CABINET MEMBER FOR ENVIRONMENT - 25 JULY 2013

PROPOSED 40MPH SPEED LIMIT AND ONE-WAY ORDER AT LAYBY - B4100 BICESTER ECO TOWN

Report by Deputy Director of Environment & Economy (Commercial)

Annex 1 - Plan showing proposals

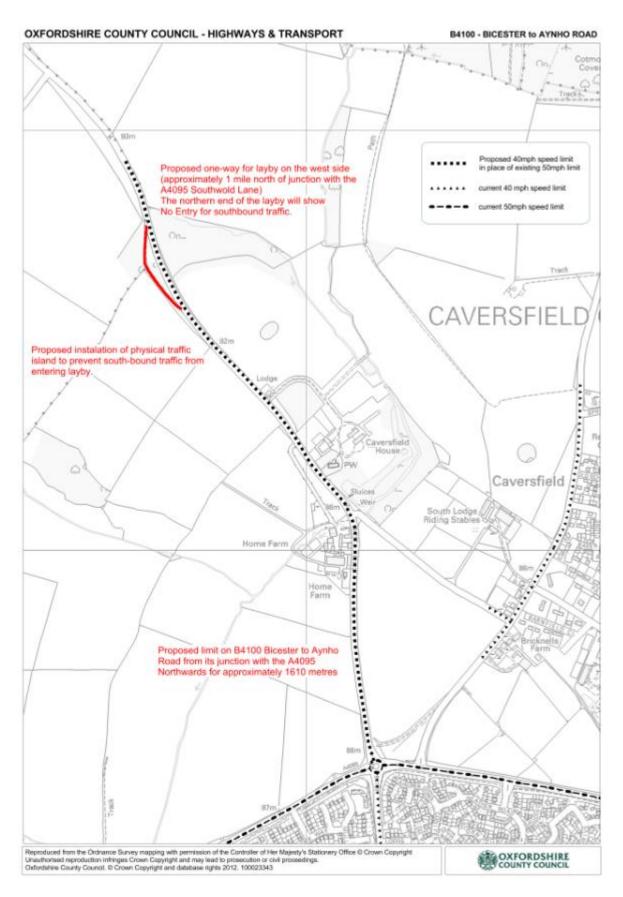
- 5. Thames Valley Police objected to the proposed 40mph limit on the grounds that the collision history did not provide a compelling case for the reduced speed limit; that the reduced speed limit was unlikely to be widely adhered to leading to a potential mismatch in design and actual speeds and to an increased potential for collision; that similar accesses on the 50mph stretch of the Bicester perimeter road did not have a significant collision history and finally, that there would be increased demands for speed enforcement to make an inappropriate speed limit respected, due to the lack of other speed restriction features.
- 6. Thames Valley Police also commented on the proposed one-way order for the layby indicating that although the proposed central island will physically

prevent large vehicles attempting a U turn, smaller vehicles might use the new junction to make such a turn.

b) Concerned that some drivers may attempt a U turn into the south end of the layby	This layout of the junction is designed to deter this movement
Caversfield Parish Council	a) No objection to speed limit proposal but request that consideration be given to replacing the current national speed limit with a 40mph limit on the roads leading into the village from the A4095 and B4100	The funding currently available only applies to works directly relevant to the Bicester Eco town development. While there would be no objection to considering these additional speed limits, a source of funding would need to be identified.

b) Concerned that some drivers may attempt to turn right into the layby	Signing will be provided to make the new restriction as clear as possible.
